TOWN OF MONUMENT 2.0 MG WATER STORAGE TANK

2.0M GALLON TANK
SITE GRADING PLAN

Site Development Plan _V2.pdf Markup Summary 1-18-2022

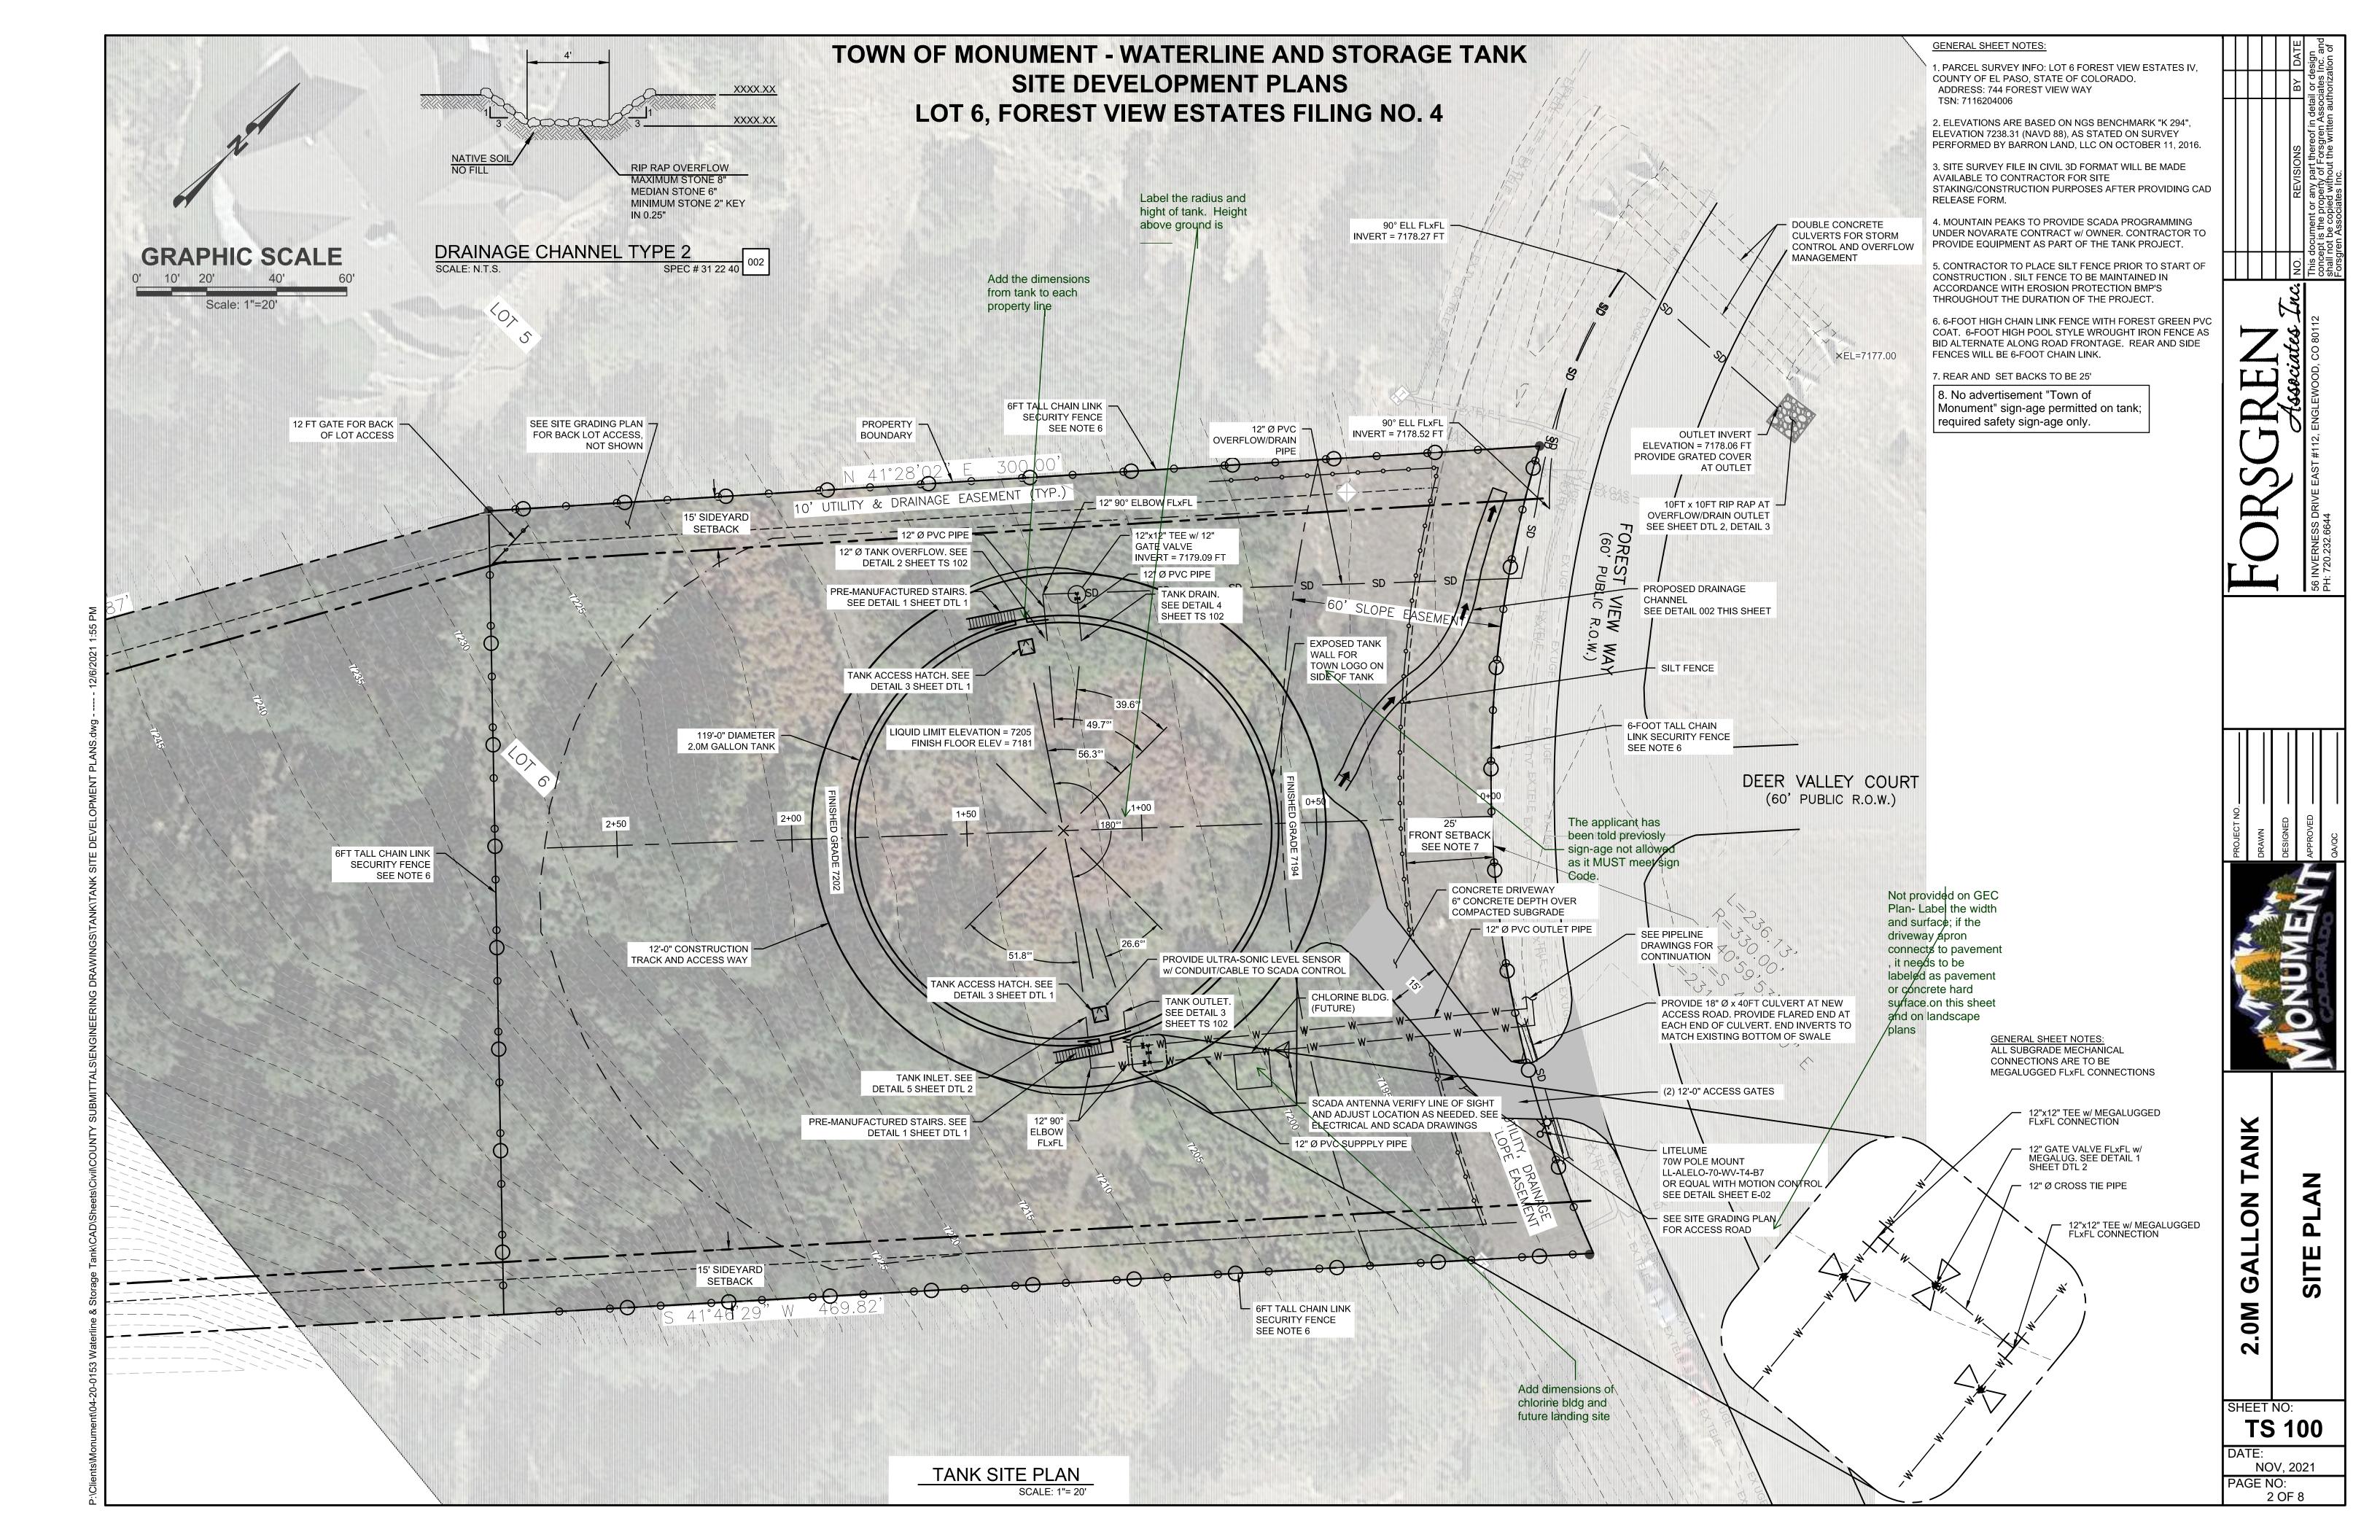
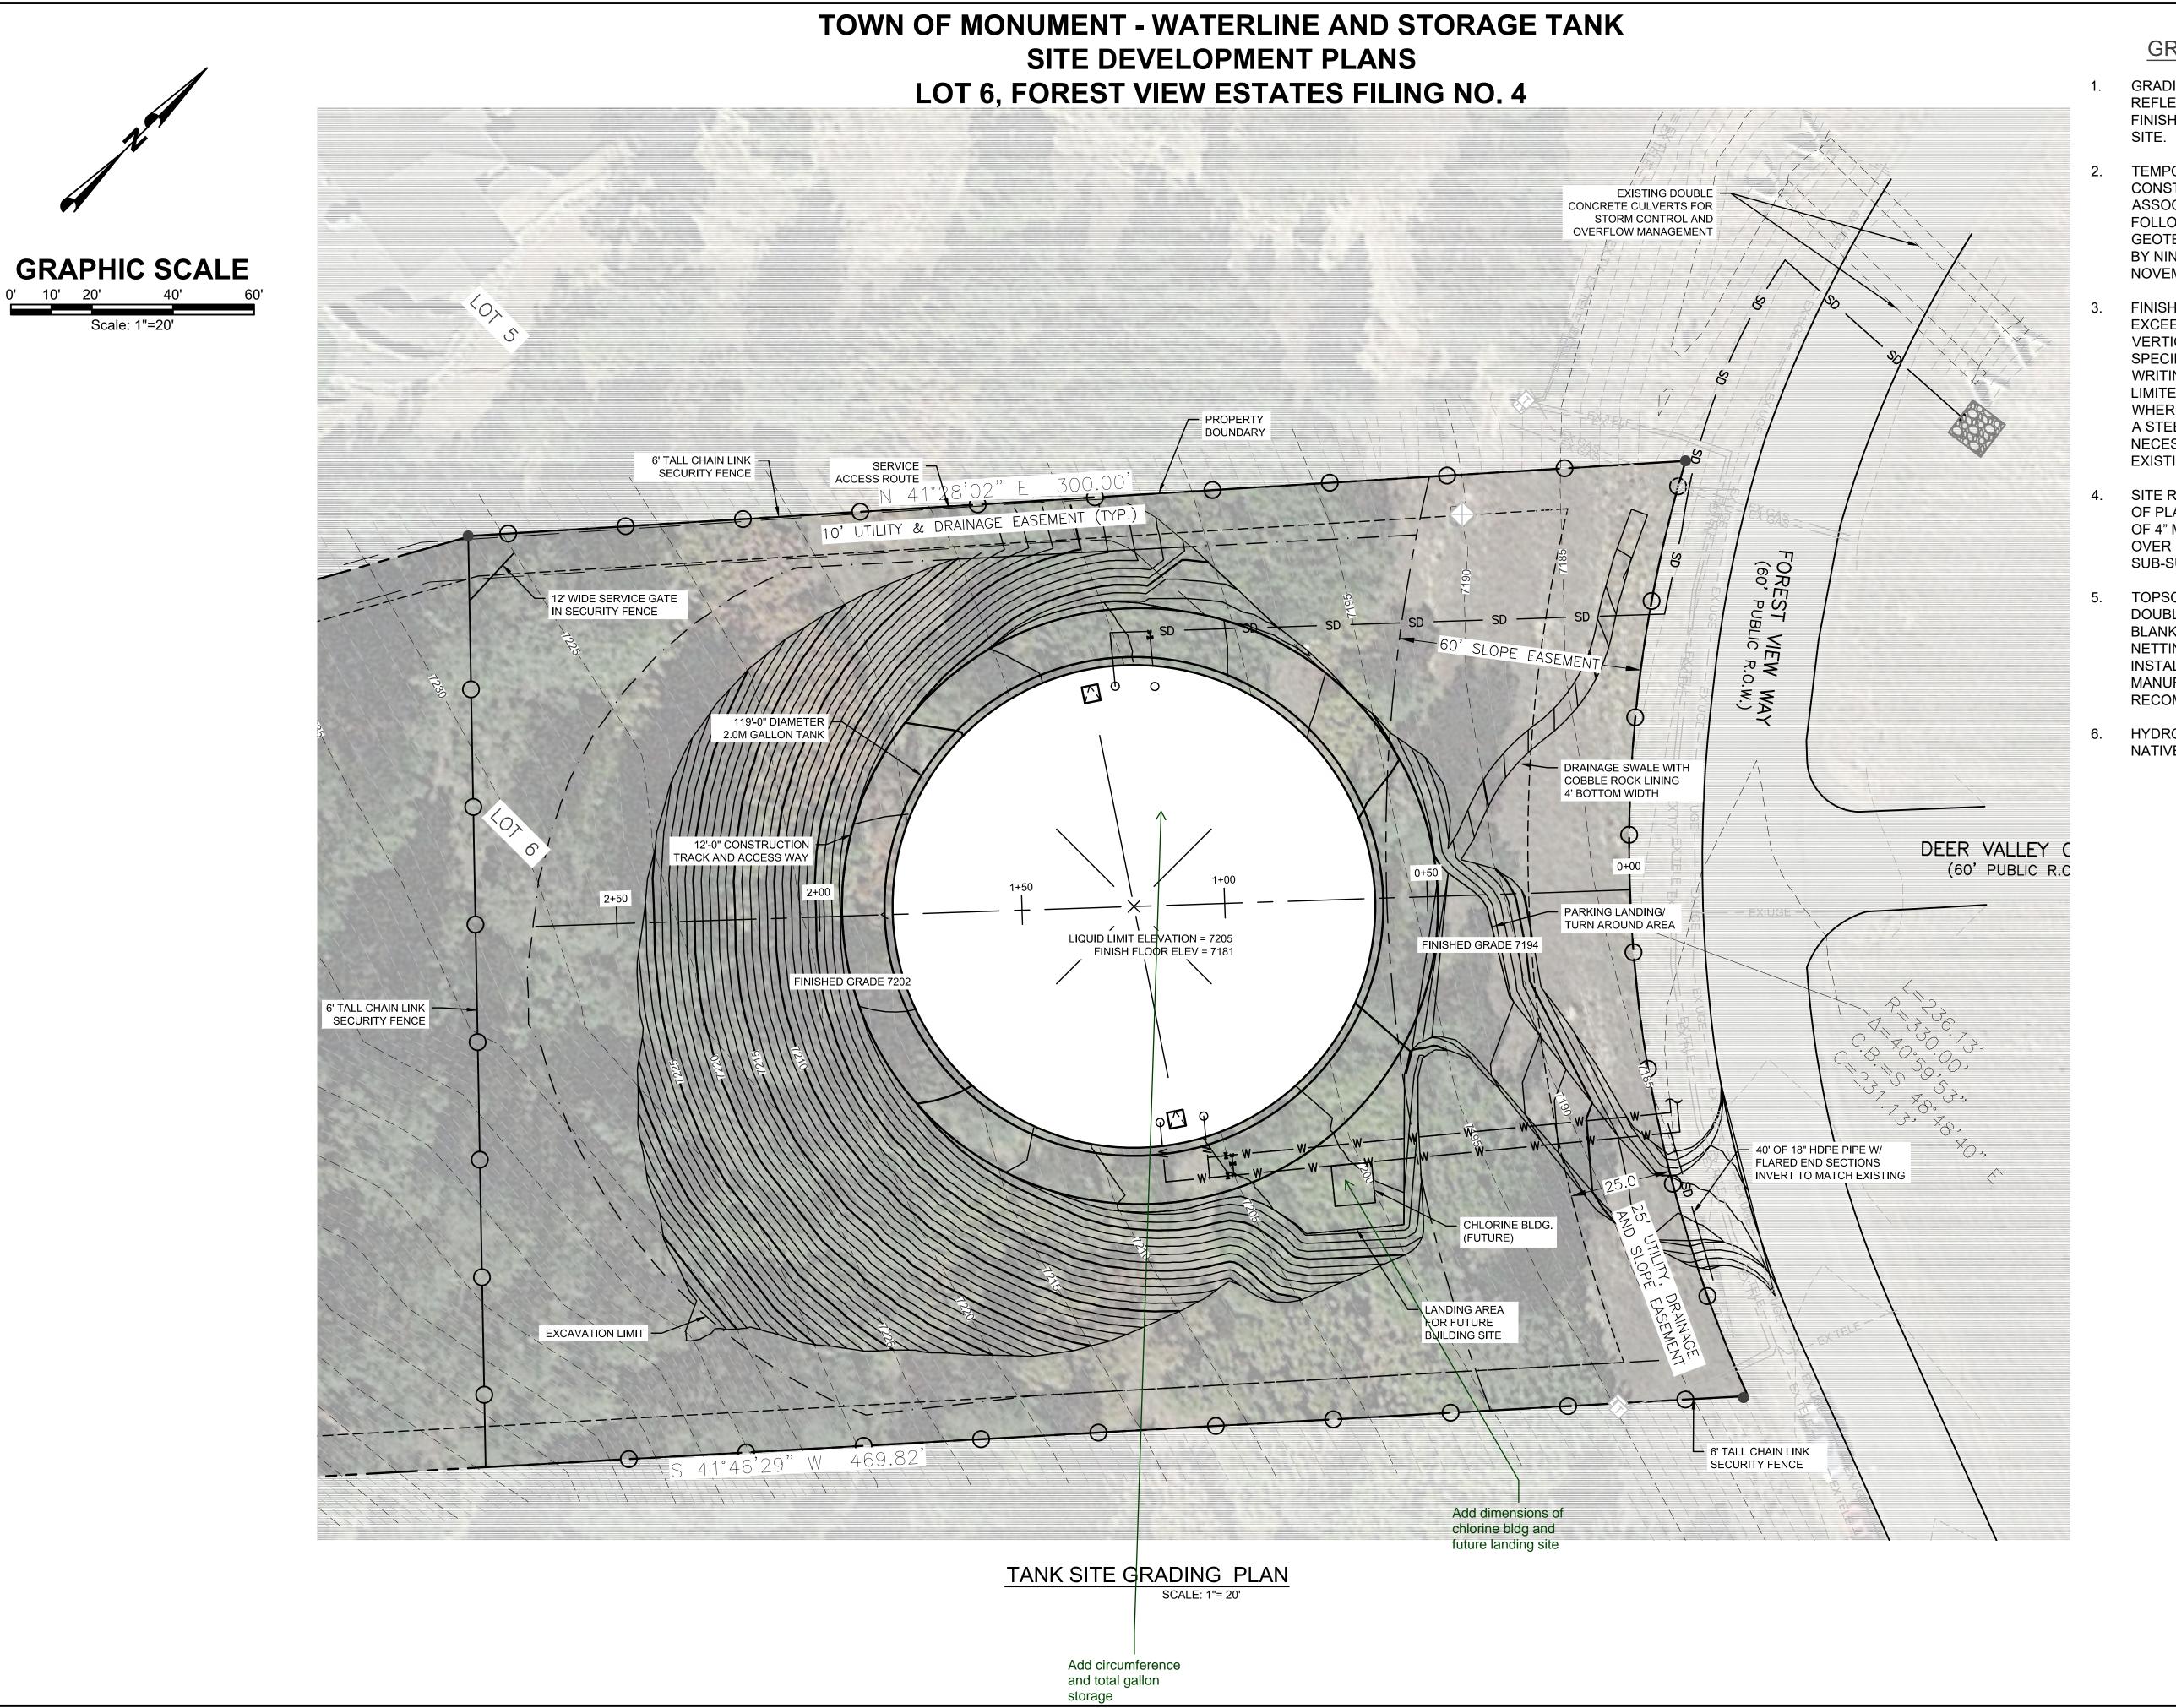
delete this... this a submittal for approval ..Add the file number to the plans in lower corner; PCD file PPR 21 30

Status: Color: ■ Layer: Space: delete this... this a submittal for approval ..Add the file number to the plans in lower corner; PCD file PPR 21 30
